October 6, 2016

SUBJECT: License Amendment Request – Supplement Application to Revise Technical Specifications to Adopt TSTF-545, Revision 3, "TS Inservice Testing Program Removal & Clarify SR Usage Rule Application to Section 5.5 Testing"

Attachment 1 provides the revised evaluation of the proposed changes. Attachment 2 provides a copy of the revised marked up TS pages that reflect the proposed changes. Attachment 3 provides a copy of the revised marked up TS Bases pages that reflect the proposed changes, for information only.

Definitions 1.1

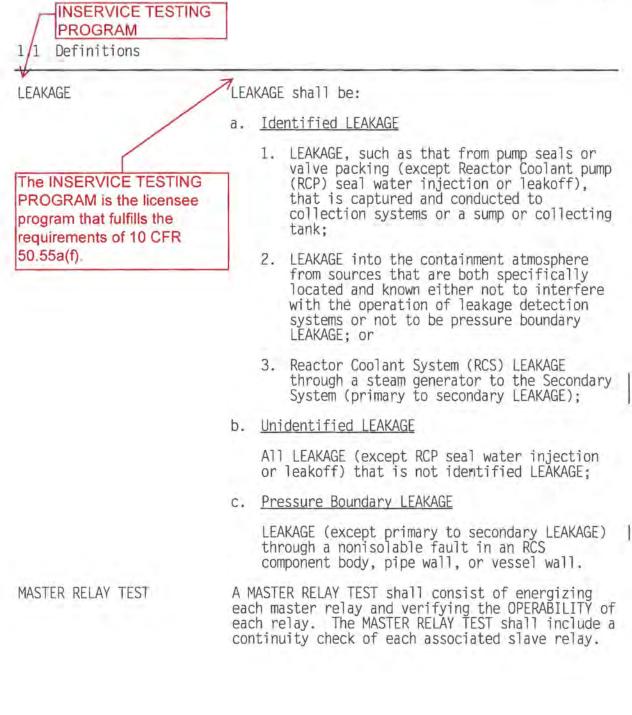
SURVEILLANCE	FREQUENCY
SR	3.4.10.1	Verify each pressurizer safety va OPERABLE in accordance with the I Testing Program. Following testi settings shall be within ± 1%.	lve is nservice ng, lift In accordance with the Inservice Testing Program
	INSER PROGE		INSERVICE TESTING PROGRAM
